CITY OF CONWAY, ARKANSAS PLANNING COMMISSION

October 21, 2024 • 5:30pm • 1111 Main Street

- A. Request for preliminary plat approval of Willow Ridge Subdivision (SUB-0723-0101)
- B. Request for preliminary plat approval of Quail Meadows Subdivision (SUB-0824-0114)
- C. Request for preliminary plat approval Millers Creek Subdivision (SUB-0924-0125)
- D. Request for preliminary plat approval Cardinal Valley Phase 2 (SUB-0924-0126)
- E. Request for preliminary plat approval extension of Lands Ends Subdivision, Phase 2 (SUB-0924-0123)
- F. Request for preliminary plat approval extension of Birds Nest Subdivision, Phase 2 (SUB-0924-0124)

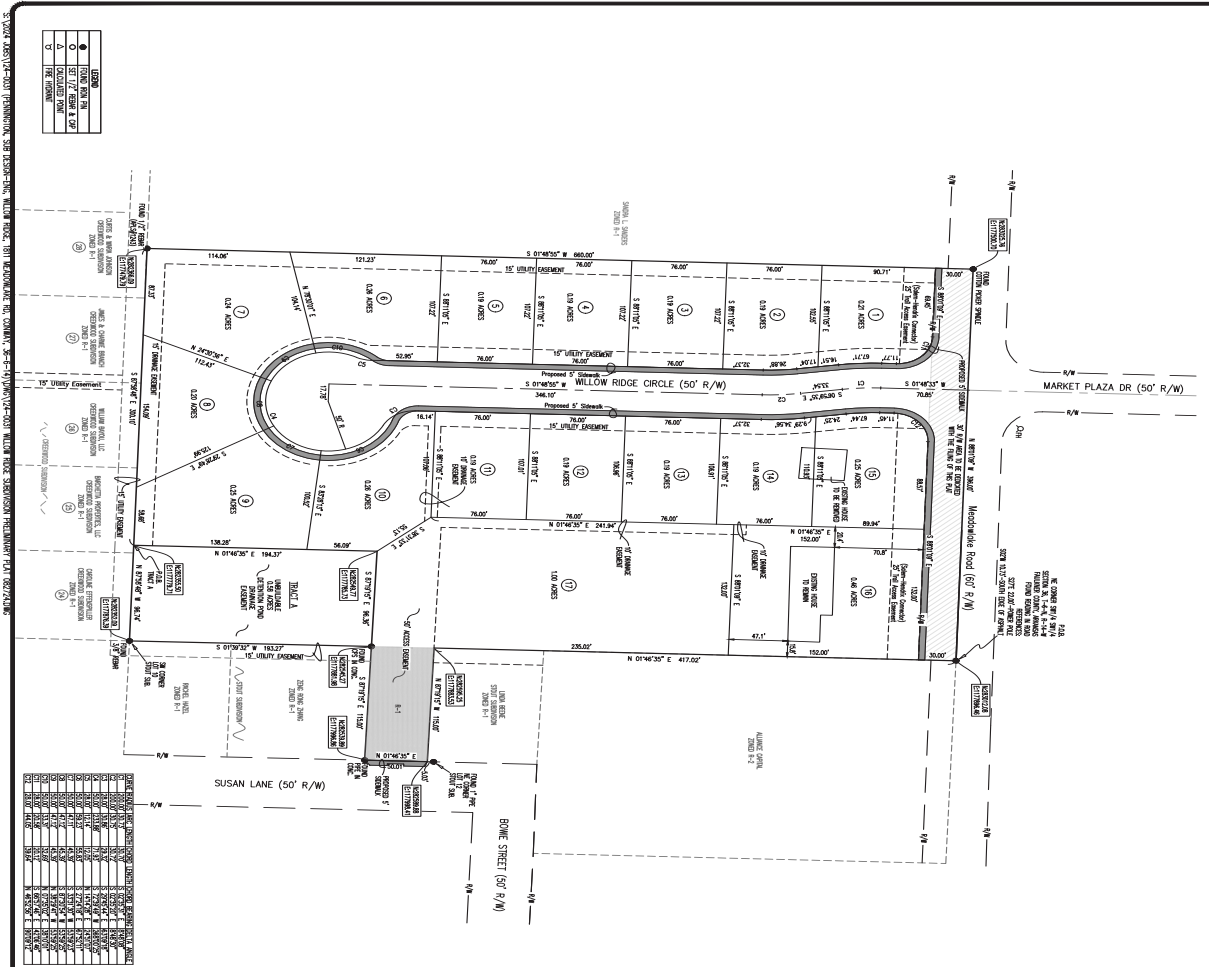
CORRECTIONS NEEDED ON THE PLAT

1. Show location of all fire hydrants.
2. Access and Drainage Easement notes need to be updated.
3. Corrections as noted on the Preliminary Plat and Street & Drainage Plans as provided to the applicant.

QUAIL MEADOW SUBDIVISION

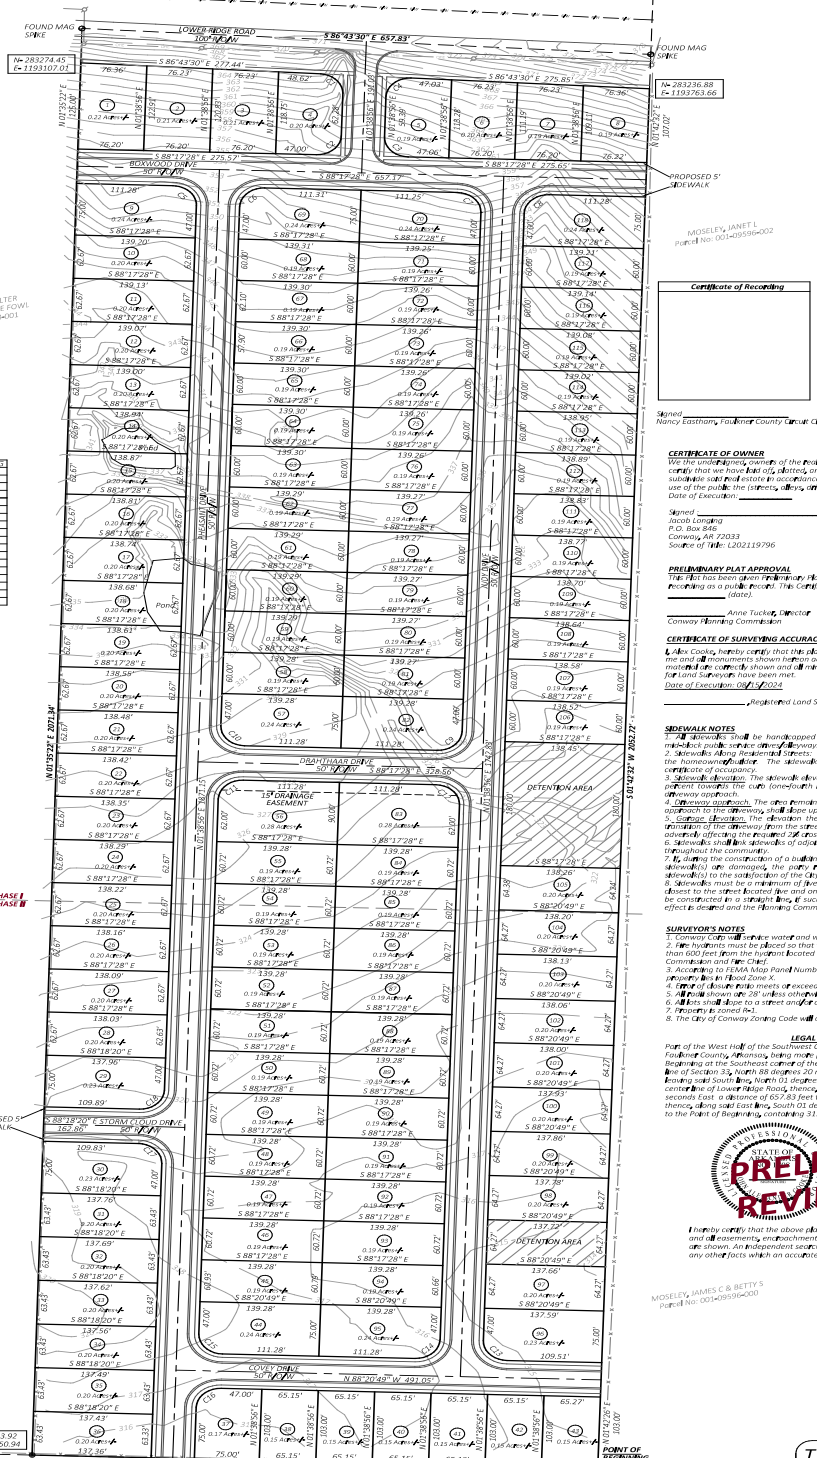
1. Creation of double frontage lots. (Article IV: Sec. 7(f)(7).

1. 10’ planting easement required on double frontage lots.
2. Developer has one ingress/egress point off Lower Ridge Rd. A maximum of 30 houses can be built with one access point. As the adjacent subdivision develops and road connections are made, additional houses can be built.

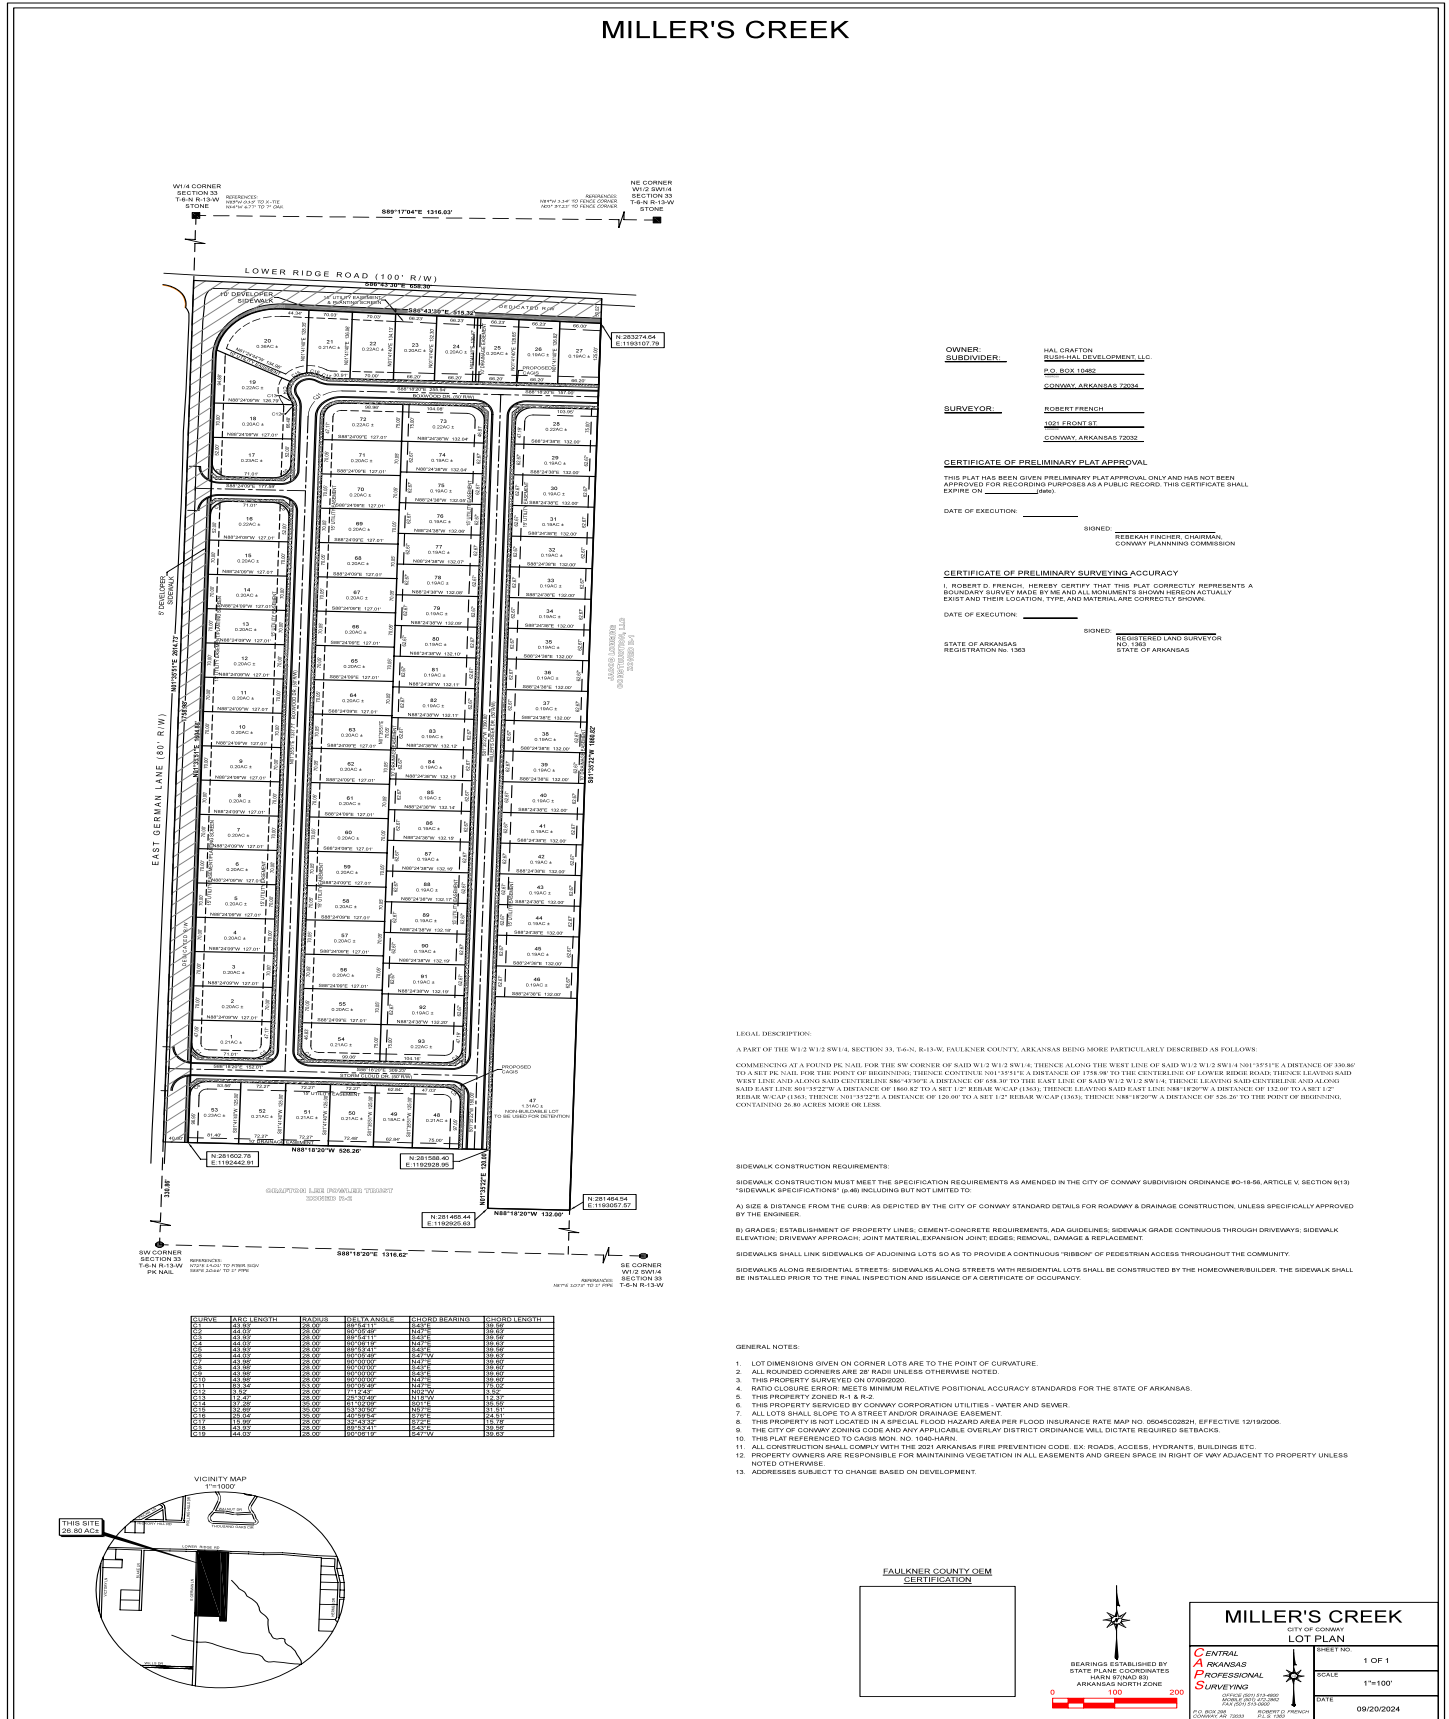
CORRECTIONS NEEDED ON THE PLAT

1. Minor arterial requires a 10' sidewalk with 6' greenspace.
2. Developer responsible for sidewalk on non-buildable lots.
3. Provide all easements as indicated by the City Engineer and Conway Corporation.
4. Other corrections as required by the City Engineer, Planning Director, and Conway Corporation on the Preliminary Plat/Street and Drainage Plans.

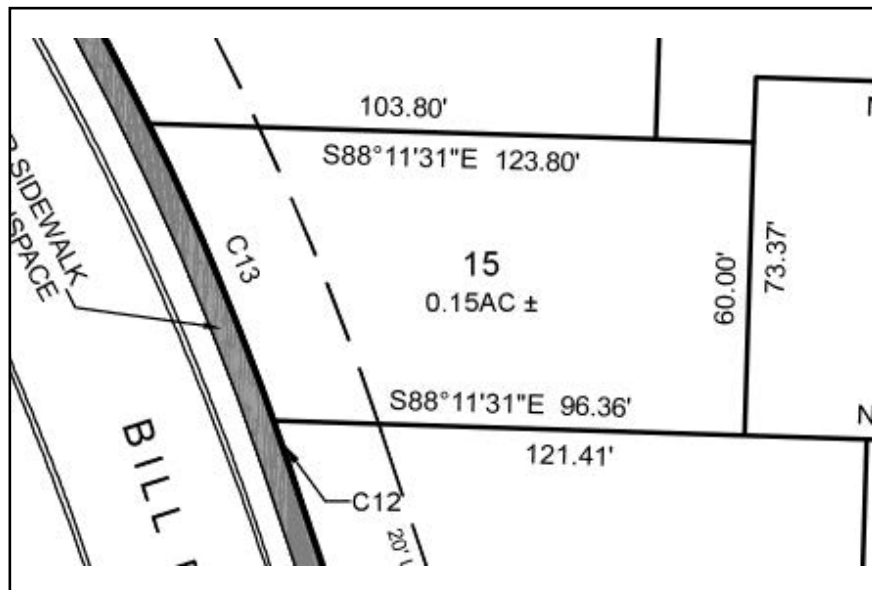
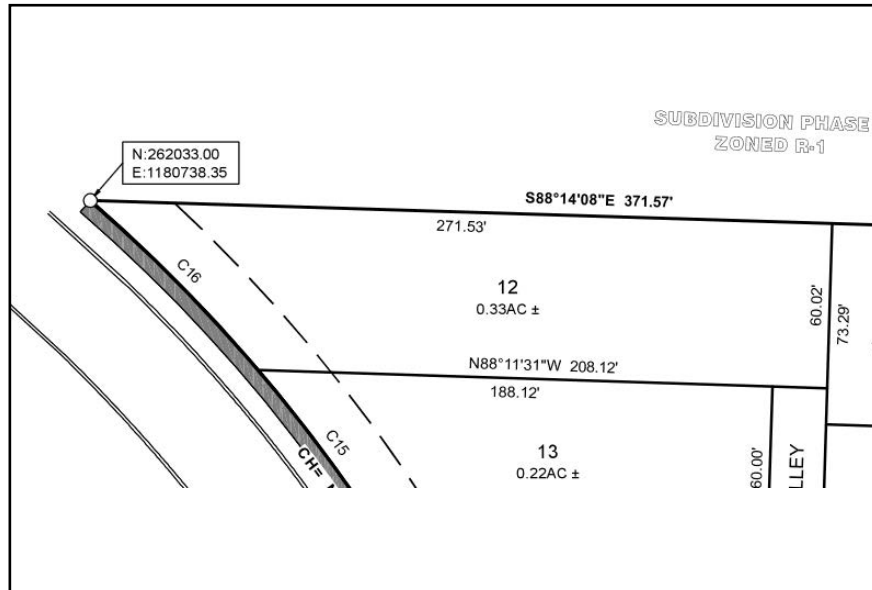
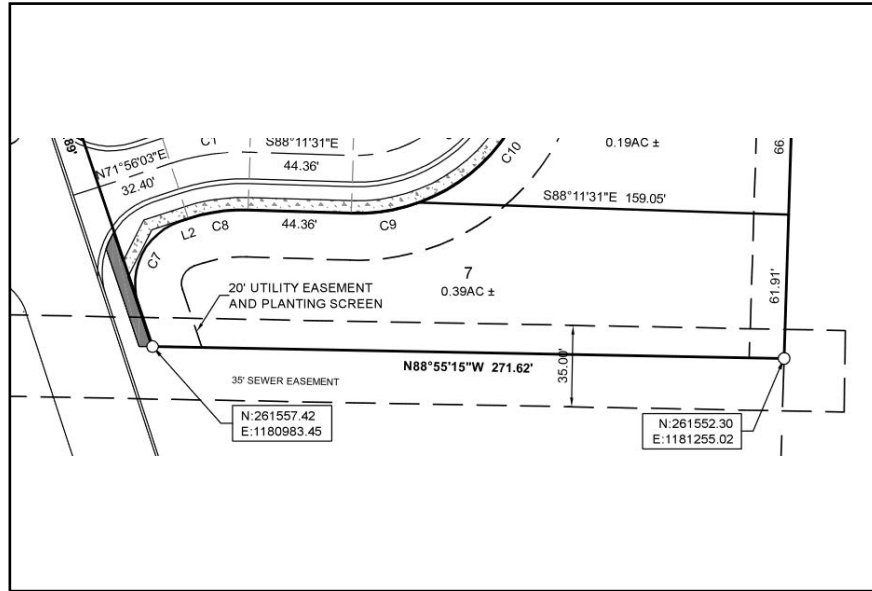
The applicant is requesting a variance for lot depths on Lots 7 and 12 to be more than four times the width of each lot and the radius less than 100'. (Subdivision Ordinance #O-00-03, Article 4, Section 5, F (3)).

CORRECTIONS NEEDED ON THE PLAT

1. Provide all easements as indicated by the City Engineer and Conway Corporation.
2. Note specifying that the developer is responsible for sidewalks along Bill Bell Lane (5' sidewalk with 7' greenspace.)
3. Other corrections as required by the City Engineer, Planning Director, Fire Marshal, and Conway Corporation on the Preliminary Plat/Street and Drainage Plans.
